**SUBJECT: COMANCHE PEAK NUCLEAR POWER PLANT, UNITS 3 AND 4
DOCKET NUMBERS 52-034 AND 52-035
RESPONSE TO HYDROLOGY SAFETY REVIEW OPEN ITEMS
(SECTIONS 2.4.12, 2.4.13, AND 2.5.4)**

Attachment 1 includes the six questions and their supplemental responses, and Attachment 2 provides the marked-up pages that incorporate the supplemental responses into the Final Safety Analysis Report (FSAR). For each mark-up, the associated supplemental response is annotated in the right margin. To assist the reviewer, the context of the marked-up pages is enhanced by including adjacent pages which may not have been changed.

Supplemental Responses to Requests for Additional Information

RAI 4314 (CP RAI #147) Question 02.04.12-8 S01
Question 02.04.12-9 S02

Figure 2.4.12-215 Post Construction Release Flow Path #3

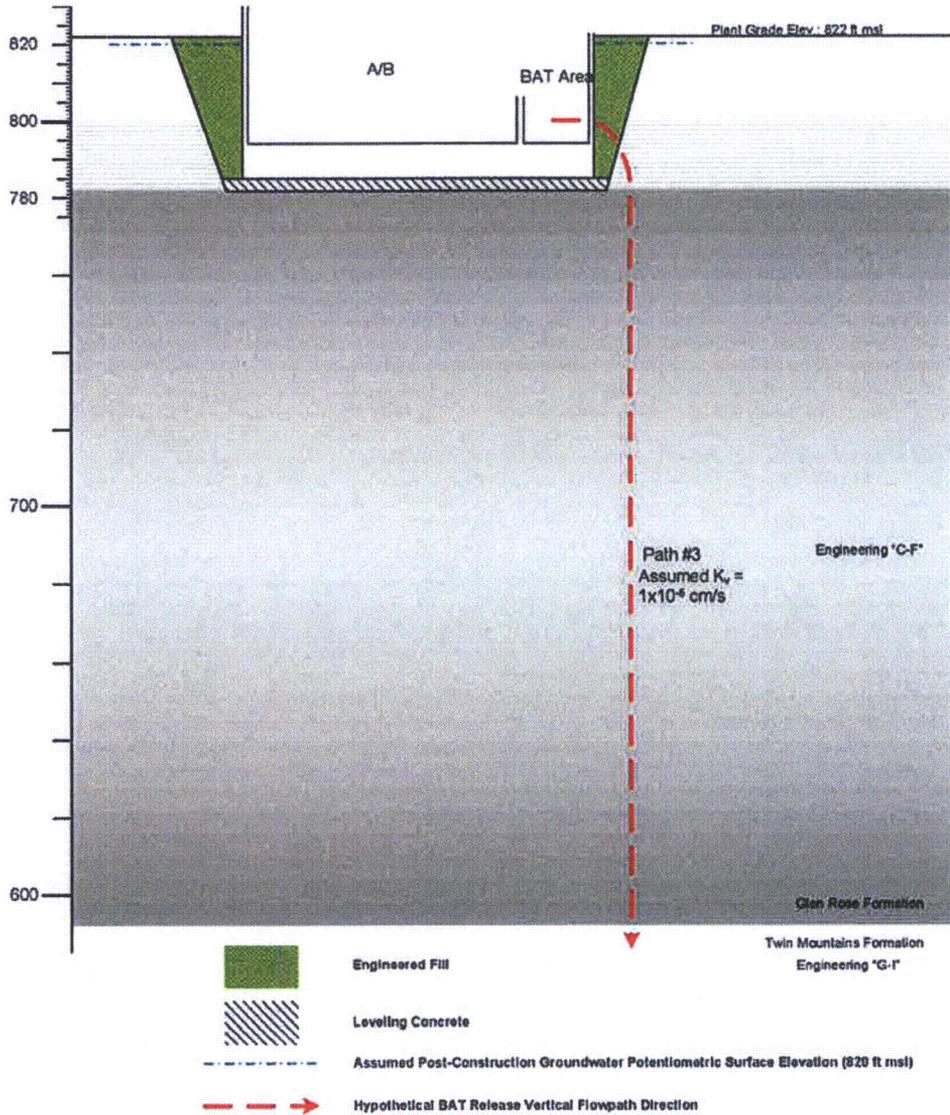
For groundwater Path #3 (Figure 2.4.12-215), it is assumed that an instantaneous release from the BAT would travel out of the CPNPP Units 3 or 4 A/B into the engineered fill surrounding the A/B and R/B. Although vertical groundwater movement is considered improbable due to thickness and extremely low hydraulic conductivity of the lower Glen Rose limestone, a hypothetical pathway was evaluated using a higher hydraulic conductivity (1×10^{-6} cm/s) than those measured during site investigations. For conservatism, it was assumed this pathway would allow downward advective groundwater flow from the engineered fill material surrounding the A/B to the Twin Mountains Formation. The travel time from Units 3 or 4 to the Twin Mountains Formation via the postulated vertical pathway is conservatively estimated at 6858 days (18.78 years).

Figure 2.4.12-216 CPNPP Post-Construction Groundwater Conceptual Model

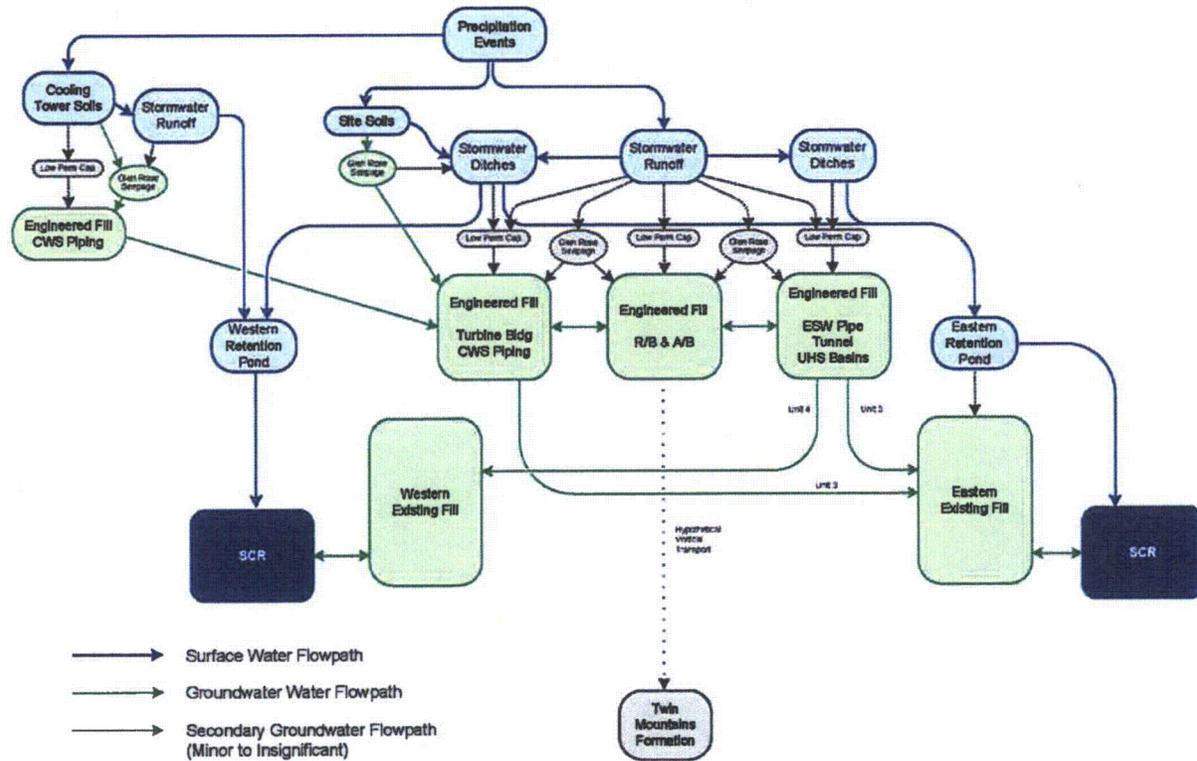
A conceptual post-construction groundwater model is depicted in Figure 2.4.12-216. The majority of the rainfall onsite will move via surface runoff into stormwater drainage ditches that discharge into stormwater retention basins located east of Unit 3 (eastern retention basin) and west of Unit 4 (western retention basin). Surface runoff from the cooling tower area will be directed to the western retention basin. Overflow from these retention basins discharges to SCR. A low permeability cap (not yet designed) is expected to be placed atop all engineered fill areas limiting the infiltration of surface water from site runoff and stormwater ditch accumulations. Although these low permeability caps will be designed to prevent infiltration, it is possible for surface water seepage into the engineered fill to occur.

Figure 2.4.13-201 Bounding Horizontal Travel Path for BAT Failure Analysis

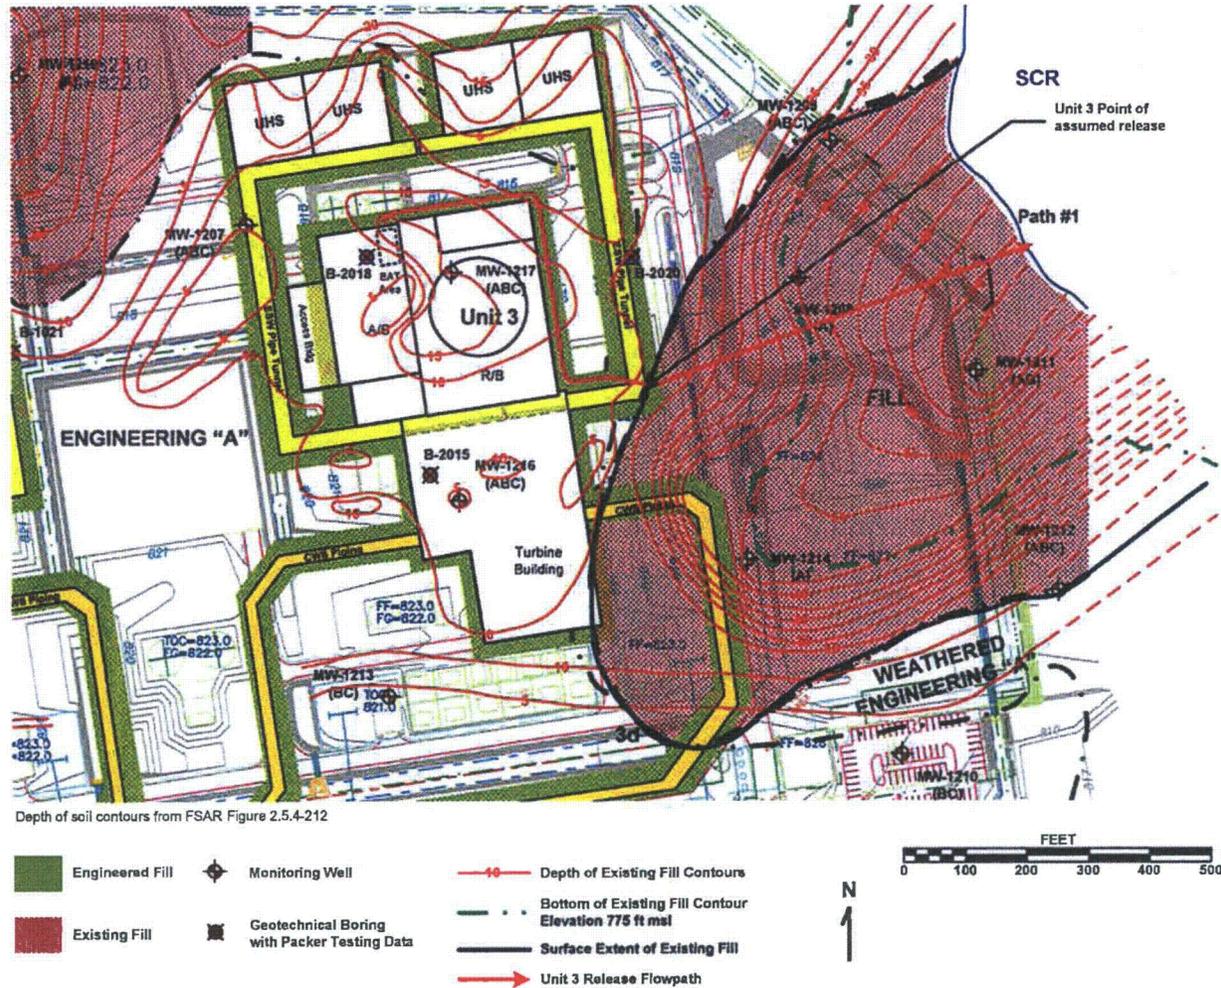
The engineered fill surrounding the ESW tunnel is in contact with the existing fill on the east side of the ESW tunnel as depicted on Figure 2.4.12-213. As depicted on Figures 2.4.12-213 and 2.4.13-201, a stormwater retention pond is located east of Unit 3 that has an overflow elevation of approximately 810 ft msl, and a bottom elevation of approximately 800 ft msl. Groundwater elevations within the existing fill will be approximately equal to the surface elevation of SCR. For the purpose of the existing fill groundwater calculation, an SCR minimum operating elevation of 770 ft msl was used. The bottom of the stormwater retention pond is
